IMPORTANT SAFETY RECALL

Date: 09/08/25
To: STXDF Ride-On Trowel Owners
From: Multiquip Product Department
Subject: Lifting D-Ring Replacement — **IMMEDIATE ACTION REQUIRED**

Service Bulletin

STXDF Lifting D-Ring Replacement

Figure 1. Lifting D-Ring Service Kit

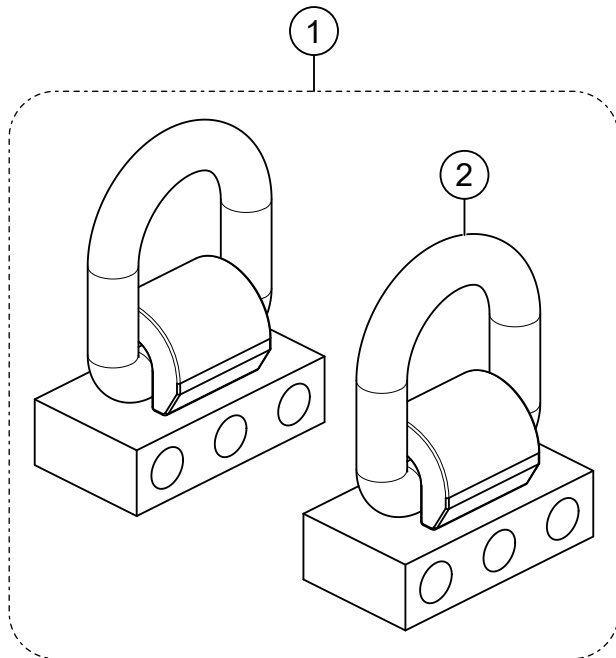
Details
Problem: Inadequate weld penetration may result in lifting D-ring failure.
Solution: Replace lifting D-rings.

Item	Part No.	Description	Qty.	Comments
1	45169-SK	Service Kit, Lifting D-Ring	1	Includes item #2
2	45169	Lifting D-Ring W/A	2

Figure 2. Remove D-Ring Hardware

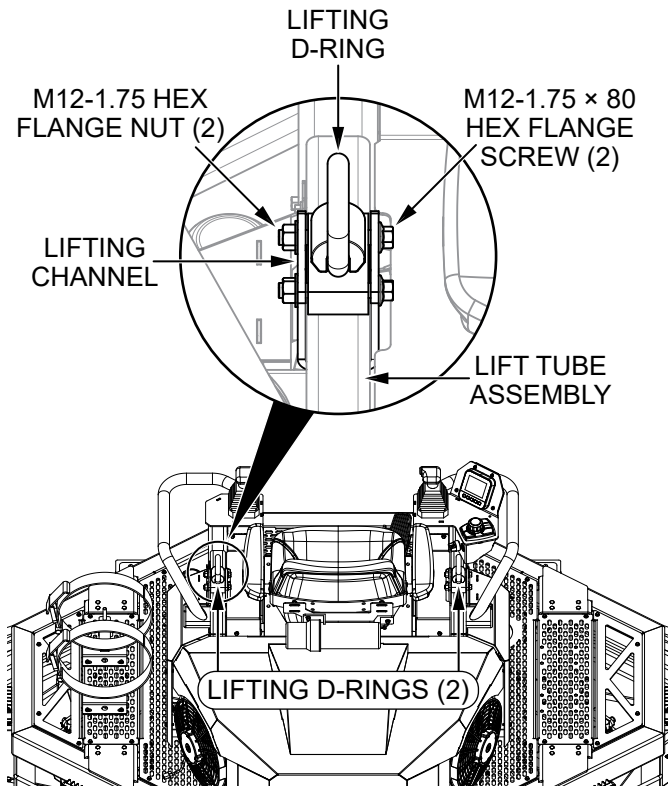
1. Remove the **two M12-1.75 × 80 hex flange screws** and **two M12-1.75 hex flange nuts** securing either one of the **lifting D-rings** to the **lifting channel** (Figure 2). Discard the lifting D-ring but retain the hardware to use during the next step.

Hold on to the **lifting channel** while removing the hardware. The possibility exists of the lifting channel dislodging from the **lift tube assembly** (Figure 2) and falling into the interior of the trowel.

Figure 3. Install New Lifting D-Ring

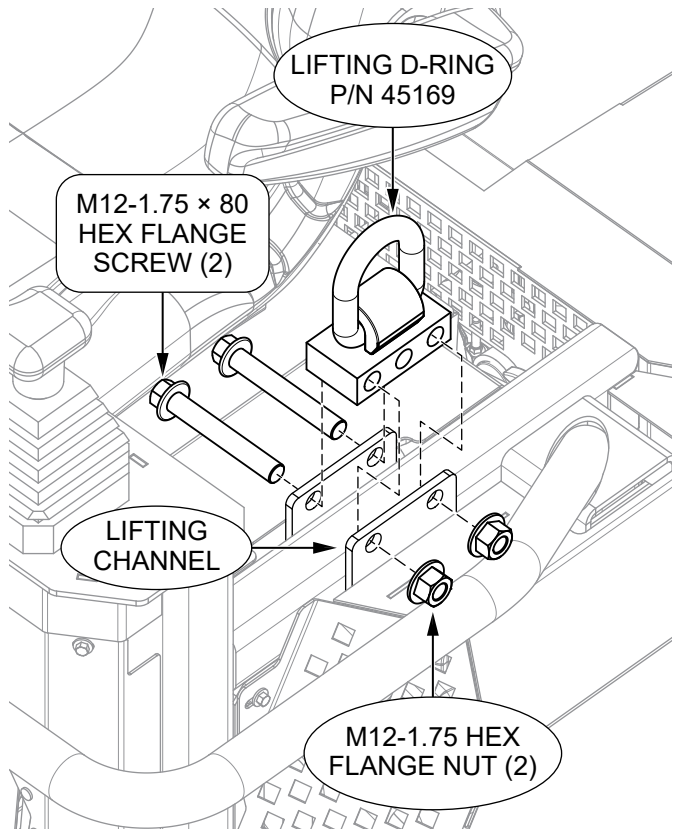
2. Use the **two M12-1.75 × 80 hex flange screws** and **two M12-1.75 hex flange nuts** that were removed during the last step to secure a **new lifting D-ring (P/N 45169)** to the **lifting channel**. Torque the screws to **70 lbf-ft (94.9 N·m)**. See Figure 3.
